SUBJECT: Negative Declaration for the
Waipio Valley Access Road Safety Improvements
TMK: 4-9-01, Hamakua, Waipio, Hawaii

FINAL ENVIRONMENTAL ASSESSMENT

**WAIPIO VALLEY ACCESS ROAD
SAFETY IMPROVEMENT PROJECT
HAMAKUA, WAIPIO, HAWAII
(TMK: 4-9-01)**

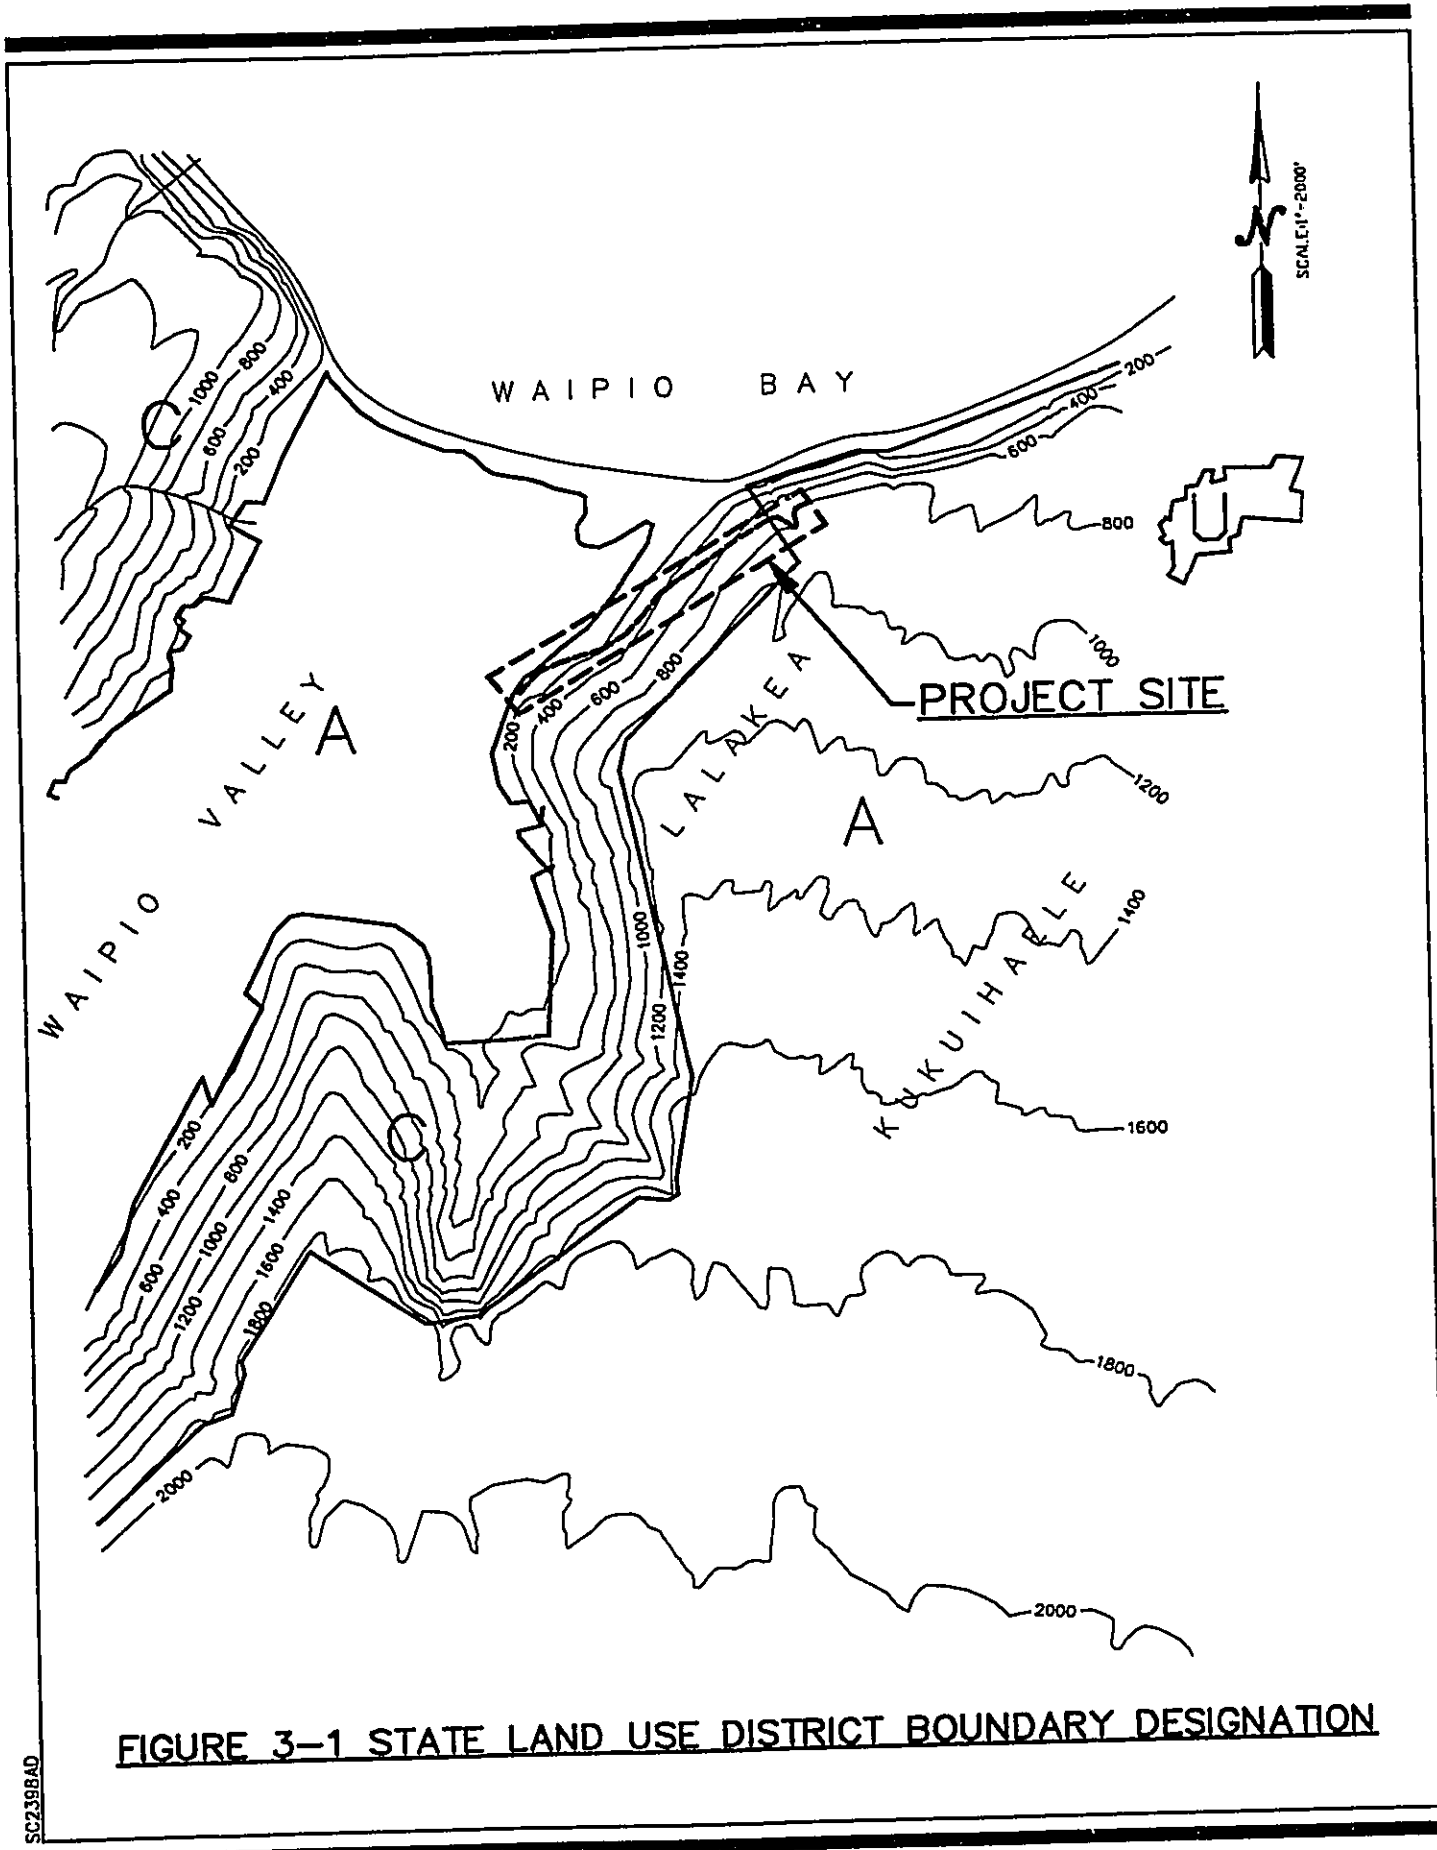
We have reviewed the subject draft EA received with your letter dated August 10, 1995, and confirm that the project site as shown on figure 3-1 appears to be located within the State Land Use Agricultural and Conservation Districts.

We would like to note that a portion of the project site appears to be proposed for reclassification from the State Land Use Agricultural District to the State Land Use Conservation District under the Office of State Planning's 1992 Five-Year Boundary Review.

Thank you for your August 23, 1995 comments on the subject project. Your comment on the reclassification of a portion of the project site from Agricultural to Conservation has been noted.

FIGURE 3-3 FLOOD ZONE CLASSIFICATION

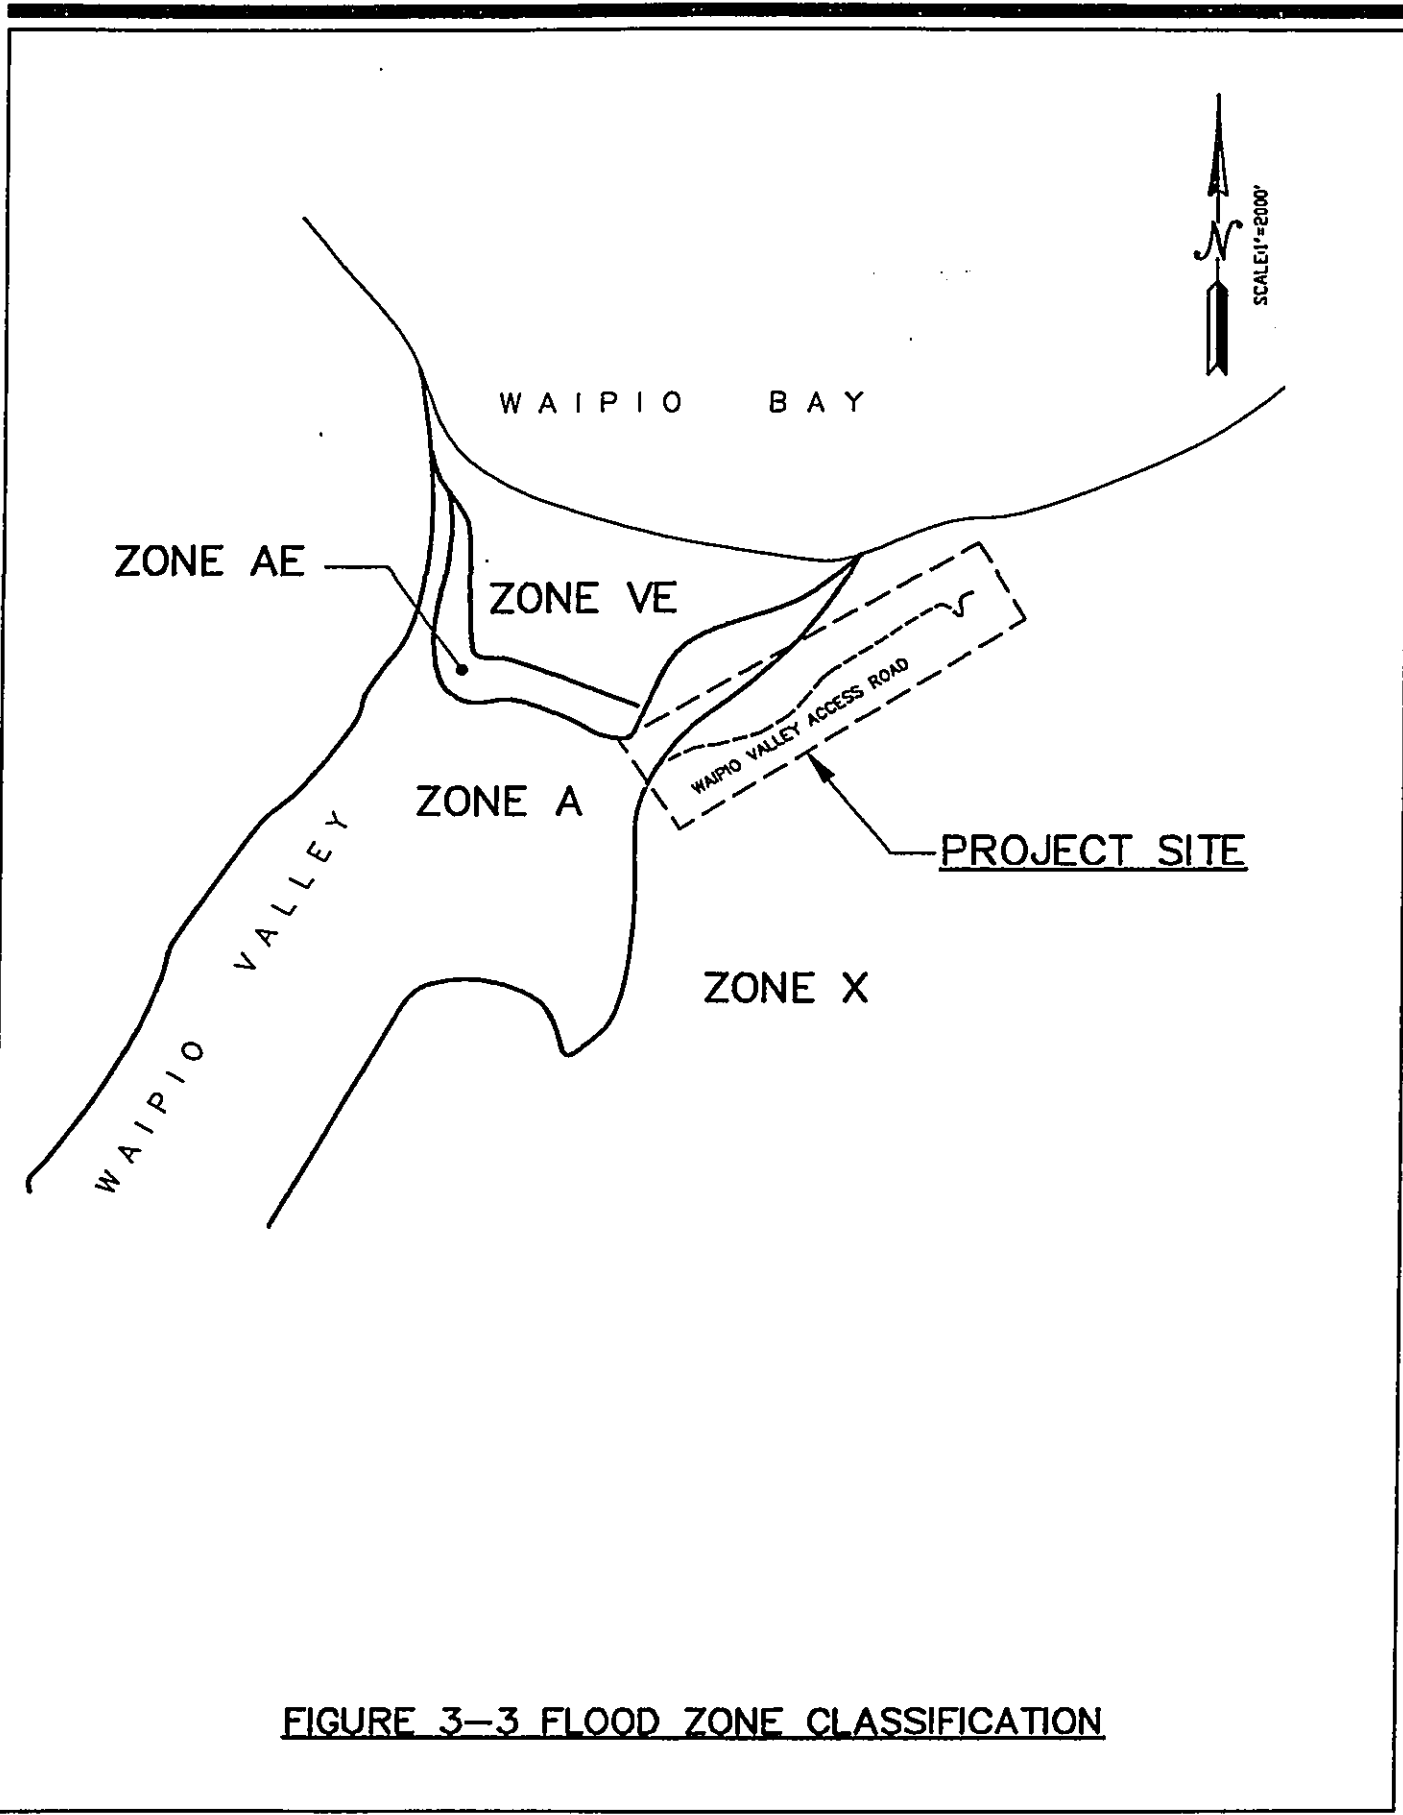
We have reviewed the Draft Environmental Assessment (EA) for the Waipio Valley Access Road Safety Improvement project. Our only comment is that the FEMA flood zone classifications referenced in the report should be updated to the new classifications as follows:

Also, page 3-5 regarding flood hazards states that most of the project site falls under the Zone X classification. However, Figure 3-3 "Flood Zone Classification" shows no Zone X.
